A G E N D A

Architectural Review Board

June 26, 2018

3412 Wellington Road

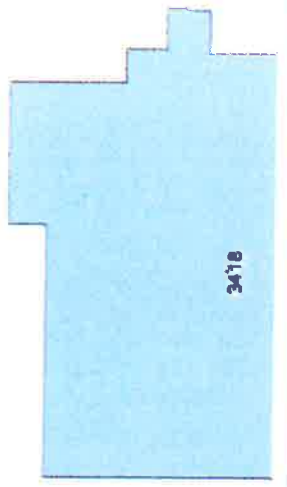
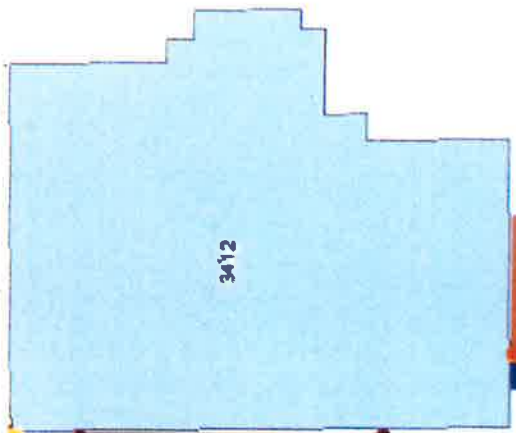
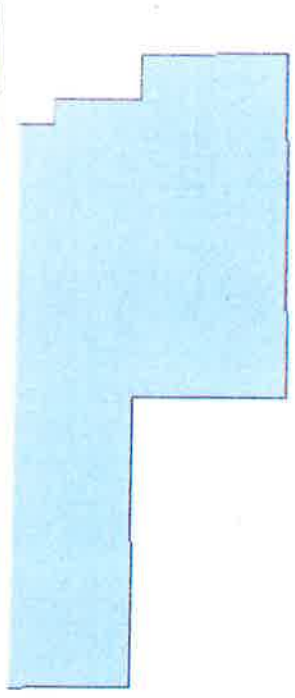
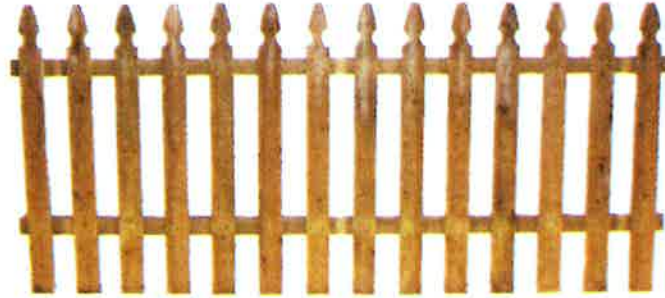
- Several years ago the Board approved the installation of a composite privacy fence, given that the composite better mimicked wood and the finish was not shiny and plastic like a vinyl fence that will warp but won't weather.
- The Board routinely approves rear yard privacy fences.

1324 South Perry Street

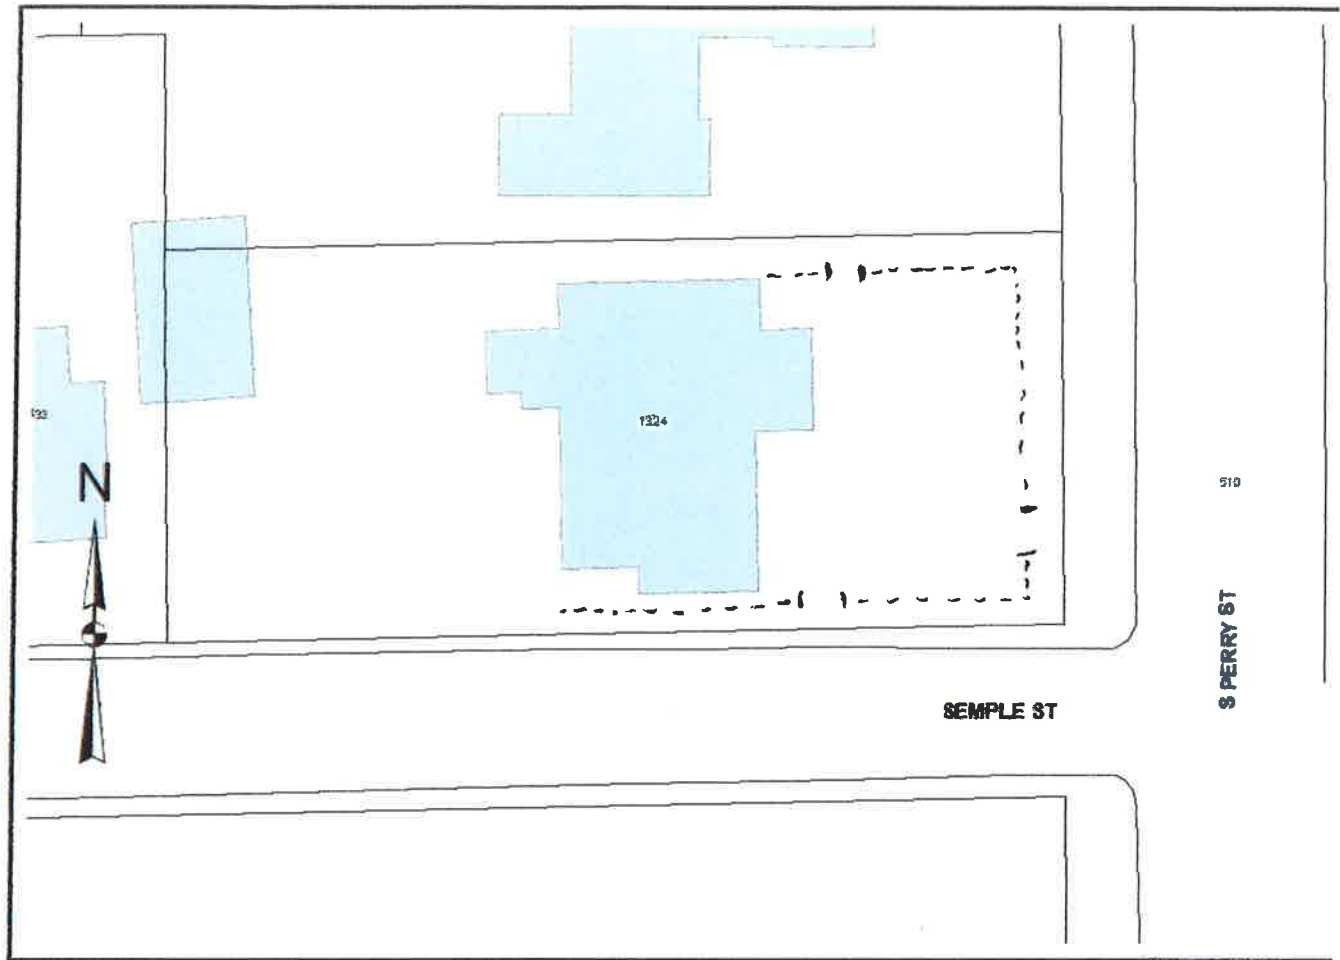
- Typical front yard fences would have been 36" to 48" in height, intending that you could have a conversation with your neighbor over the fence but delineate your property.
- Attempts to reach Mr. Bulger by phone were unsuccessful, staff assumes that the fence will be installed with metal posts and not masonry columns as pictures in the example. If Mr. Bulger wishes to construct columns, we need to know how many, the dimensions of the columns, and the distance between them, and as a solid "structure", any column over 36" in height would require a variance from the Board of Adjustment.

FRONT ELEVATION - NEW METAL GATES & FENCE

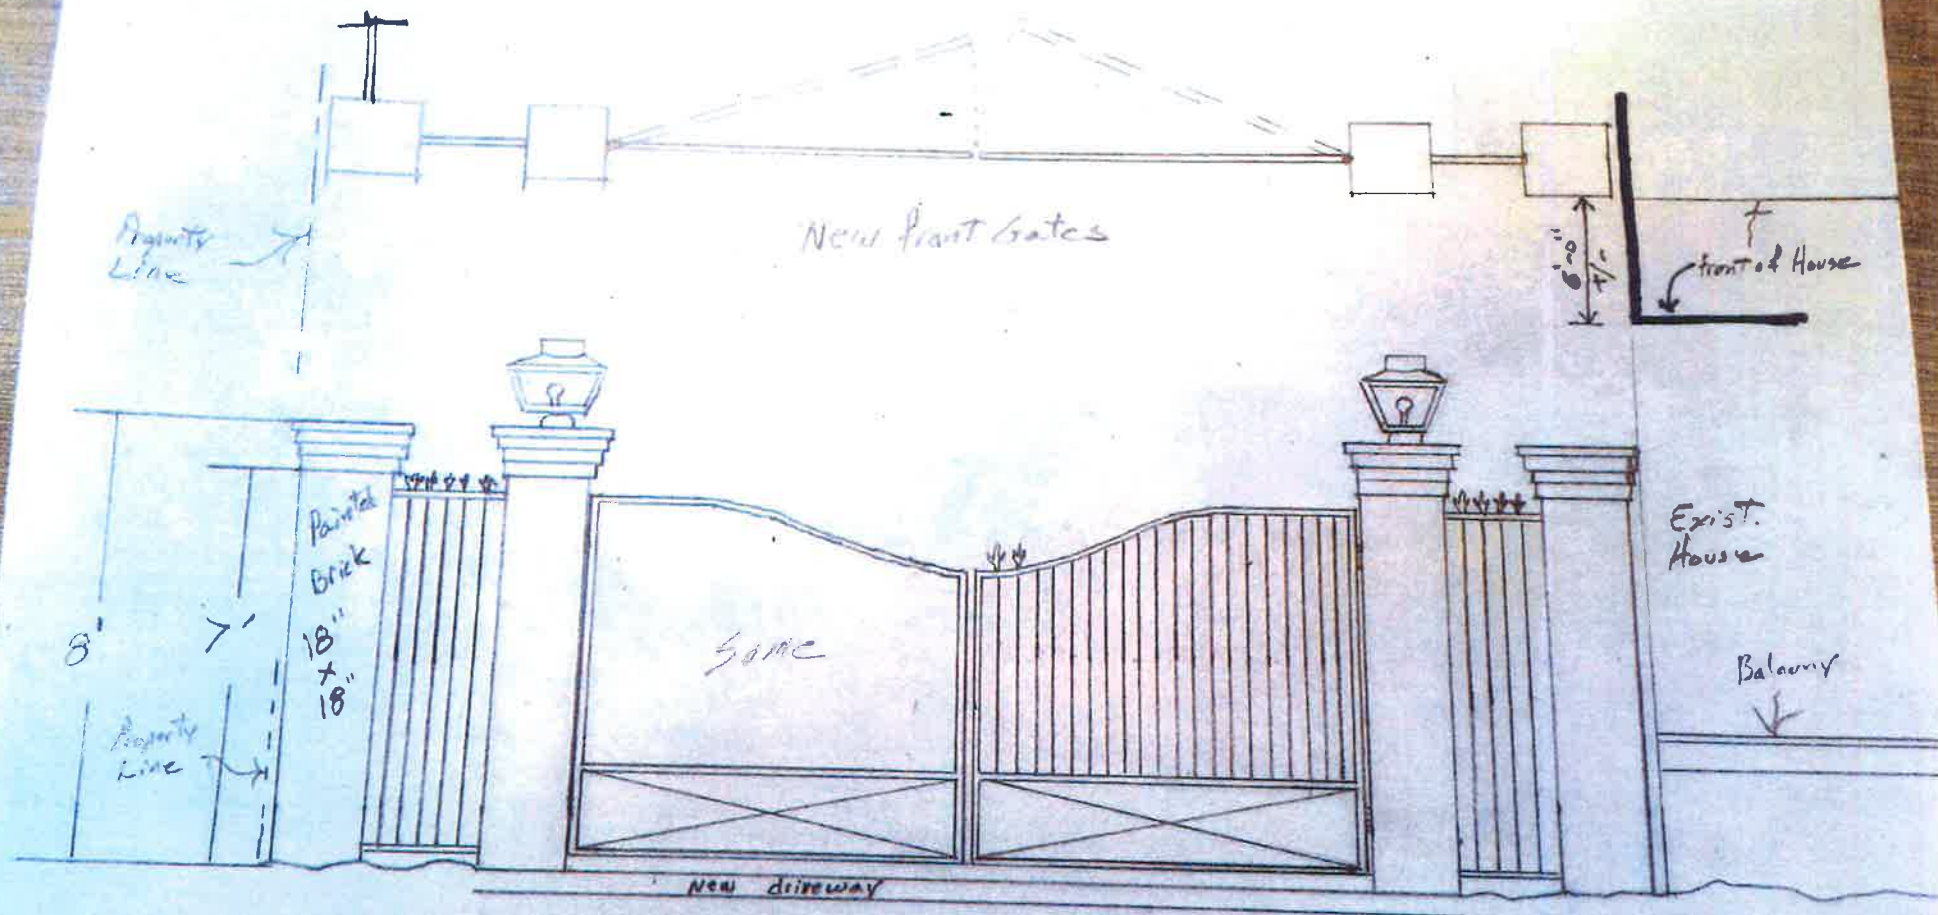
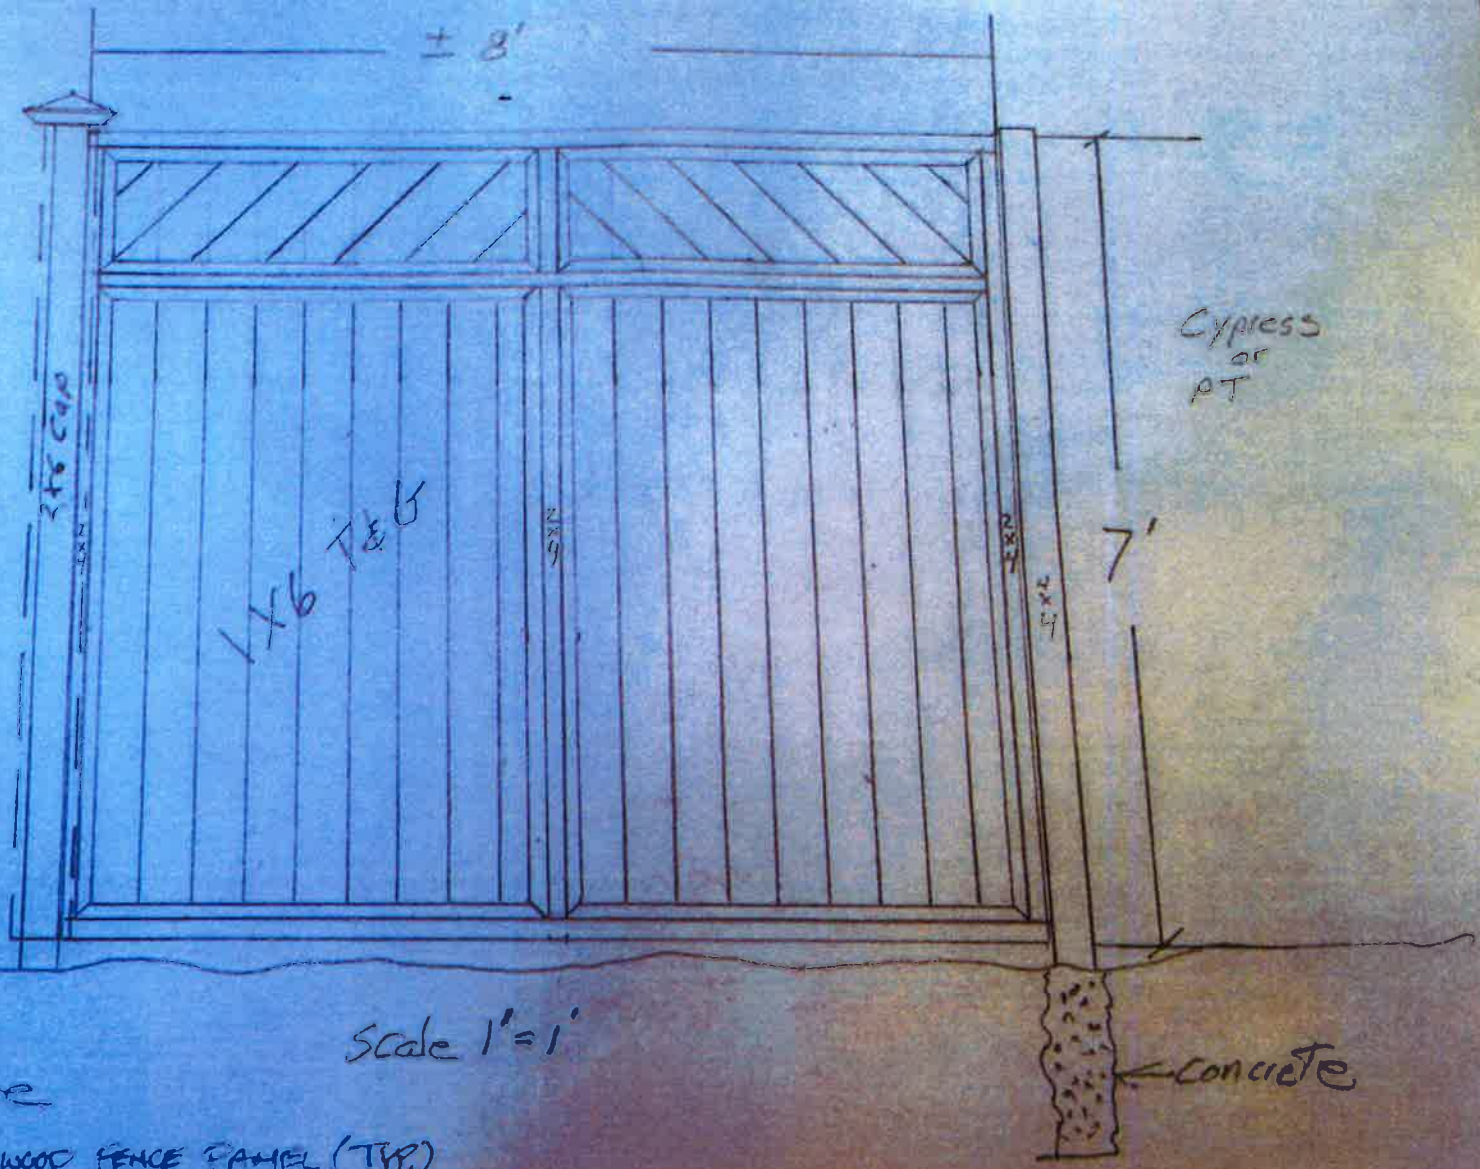
- Gate is recessed from the front corner of the house, no objection.
- The Board routinely approves rear yard privacy fences.

Simulated Divided Lite Options

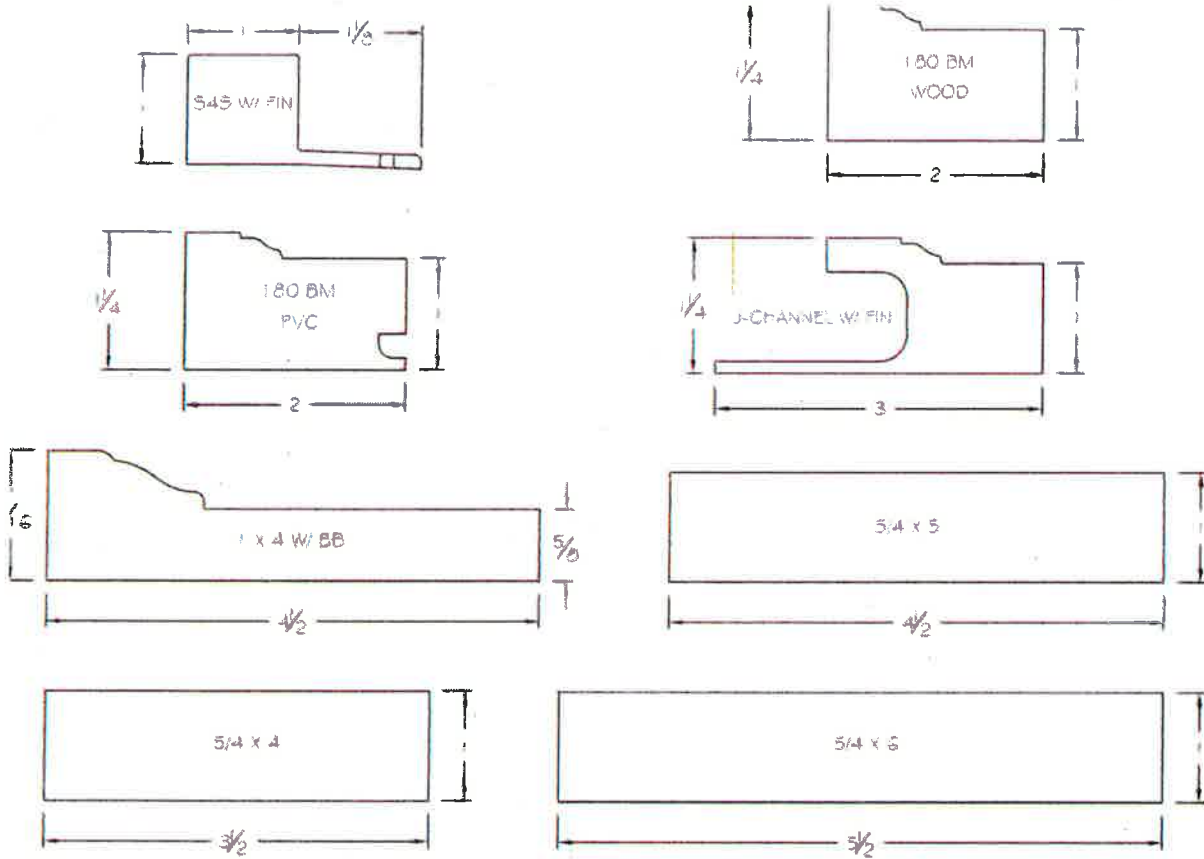
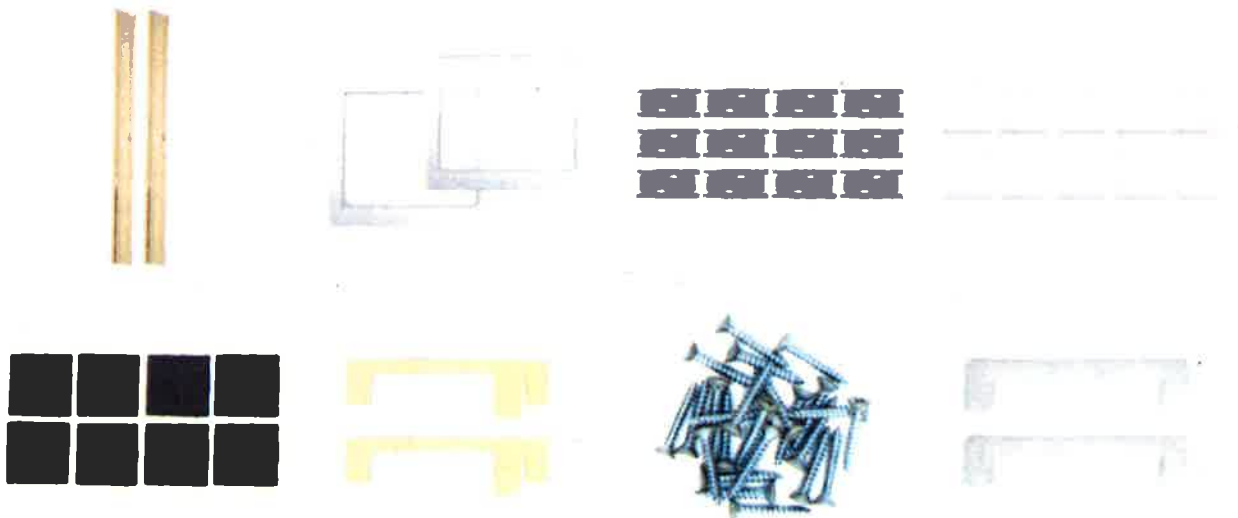
- The Board has previously approved the use of the Tucker PVC window as a replacement. This appears to be a “newer” model than what we have seen before. Muntins are 7/8” putty glaze, simulated divided lite.
- The half lite doors are closer to the 6 lite half lite door at the rear. The “craftsman” door looks more like a front door, and there is stylistically little about this duplex that says “craftsman”.
